Department of Permitting Services Fire Department Access and Water Supply Comments

DATE: 10-May-25
TO: Stephanie Castor - scastor@solteszco.com
Soltesz, Inc
FROM: Marie LaBaw
RE: Viva White Oak
12018024A

Re: Viva White Oak Performance Based Design Review
Preliminary Plan Amendment #12028024A

RE: Sketch Plan and Preliminary Plan Letter
Sketch Plan No. 320240080:
Preliminary Plan No. 120180024A
Viva White Oak

FIRE ACCESS PLAN

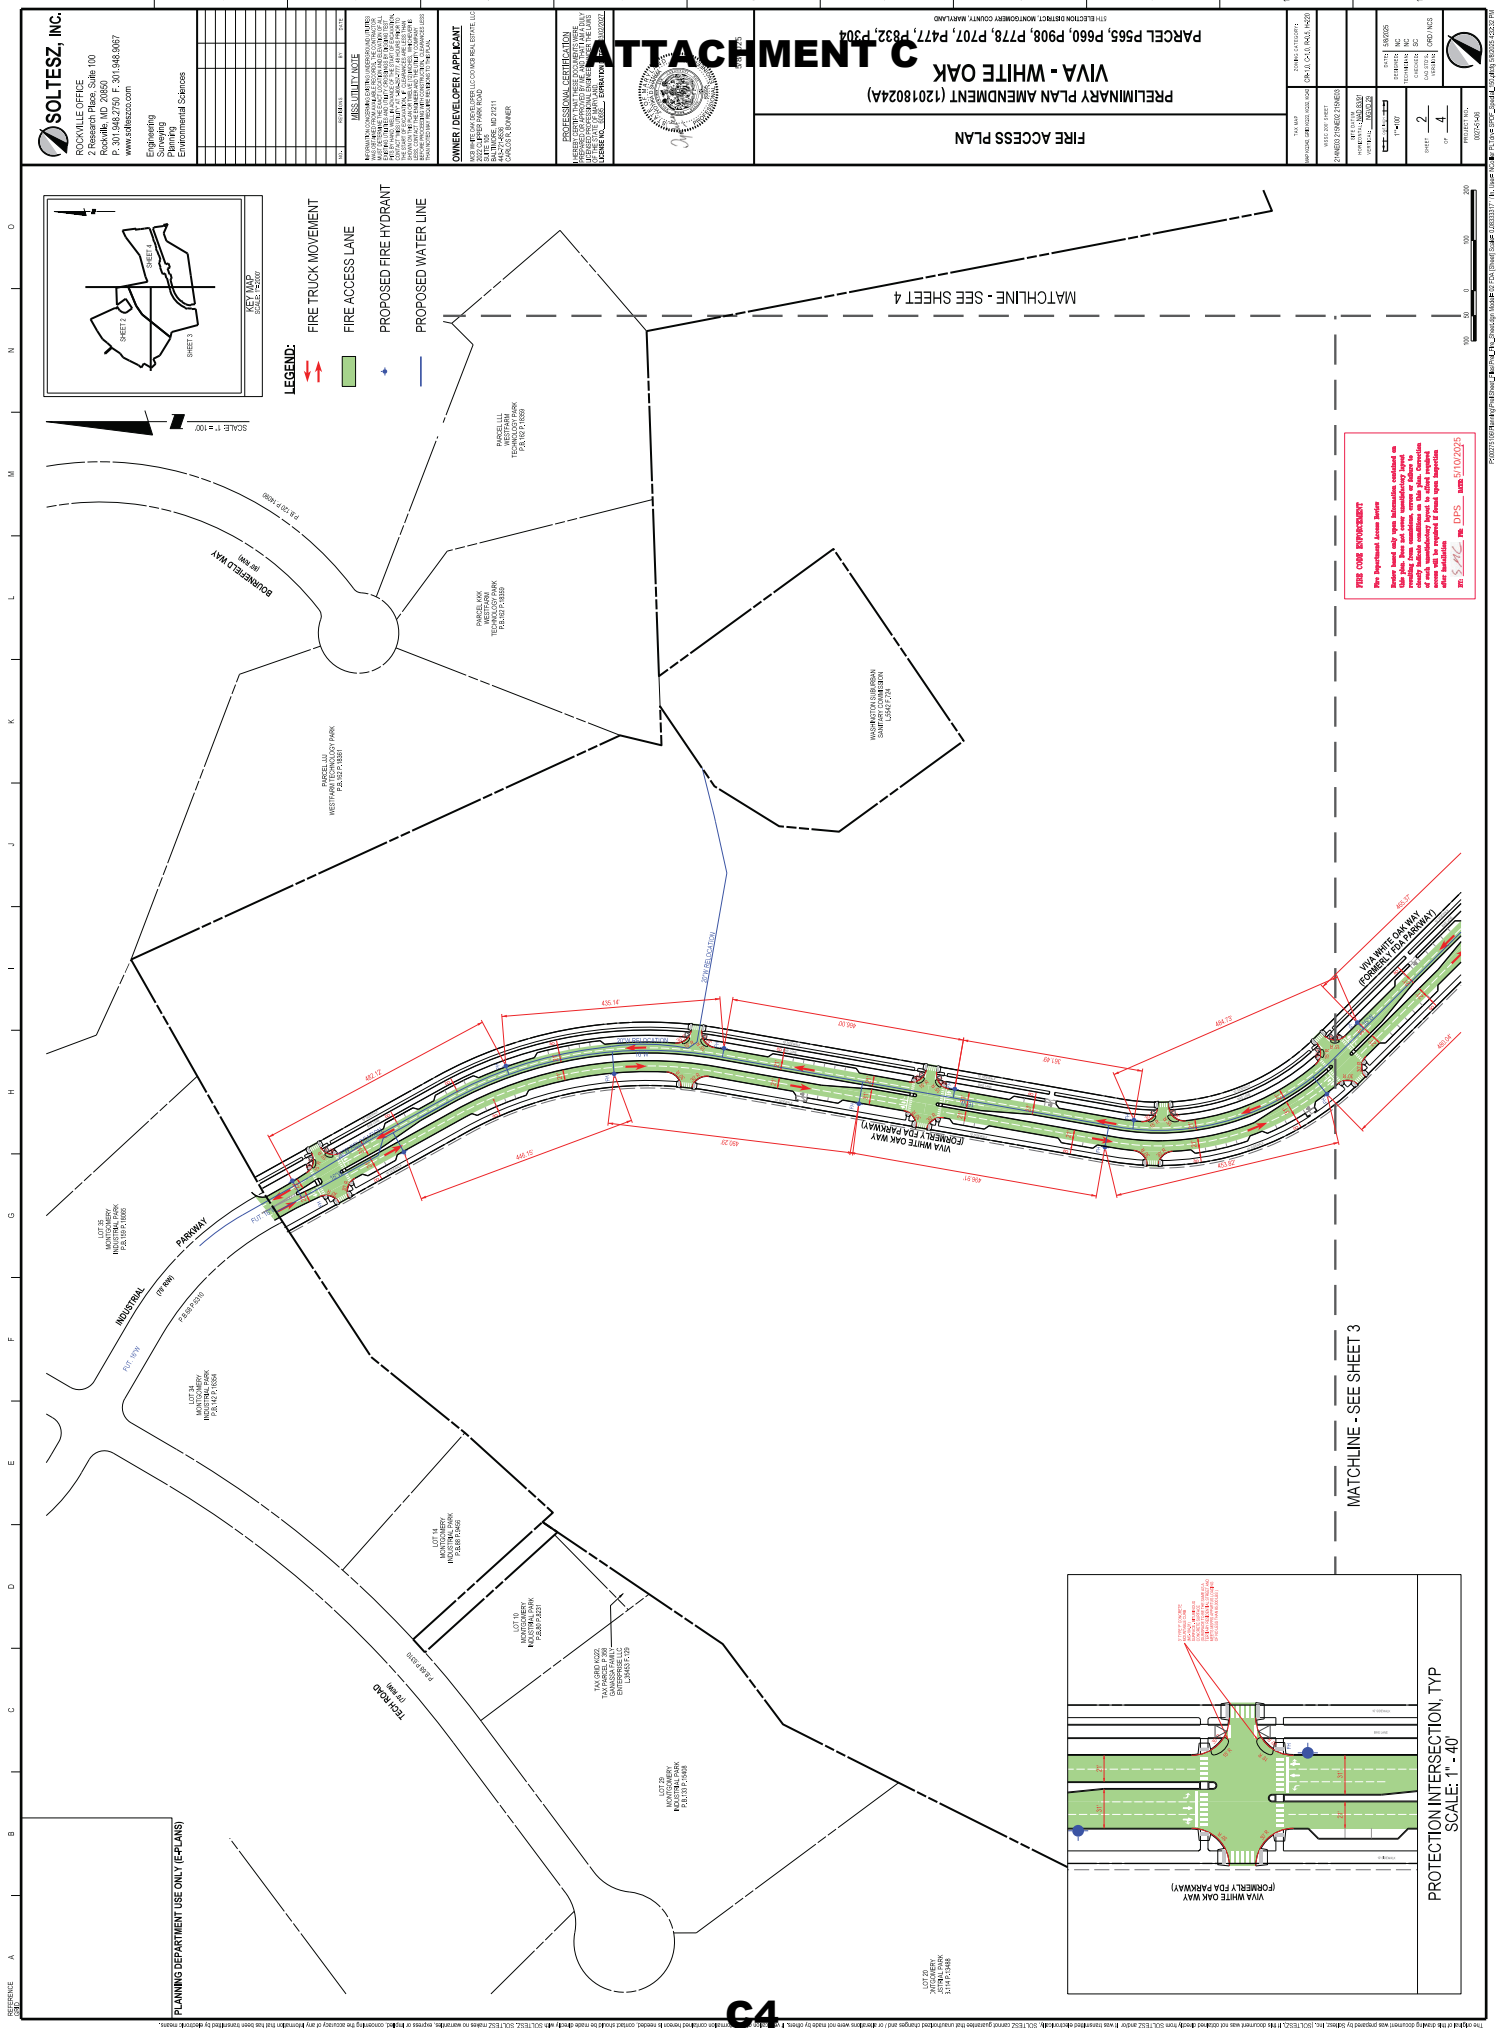
As shown on the FDA Plan, there is an existing conspan style bridge (Manufactured by Contech) over a stream valley that will remain as part of the new Master Plan Roads design being constructed under this Preliminary Plan Amendment. The existing abutment span is approximately 565 feet and the existing street section across the bridge is approximately 61 feet between sidewalks. Due to the span and width of the existing conspan bridge this development is unable to abide by 500 foot spacing required between fire hydrants per Chapter 22.00.07.88. The Preliminary Plan Amendment provides a fire hydrant at each end of the existing bridge abutment for a total spacing distance of 598 feet. The developer would like this distance to be reviewed and approved. (All other hydrants along Master Plan roads will meet the 500' spacing requirement.)

There will not be buildings along the sides of the conspan bridge, therefore, it is expected that the only incidents requiring use of the hydrants will be for vehicular fires and collisions. In this regard, with the hydrants located 598 feet apart as proposed, the maximum distance for a hose to reach a fire on the bridge is 299 feet. This distance does not exceed typical hose lengths. For these reasons, we believe that the performance based design in this case will provide adequate access and response capability for fire apparatus.

PLAN APPROVED

Fire Department Access Review

BY: SAC FM: DPS DATE: 5/10/2025
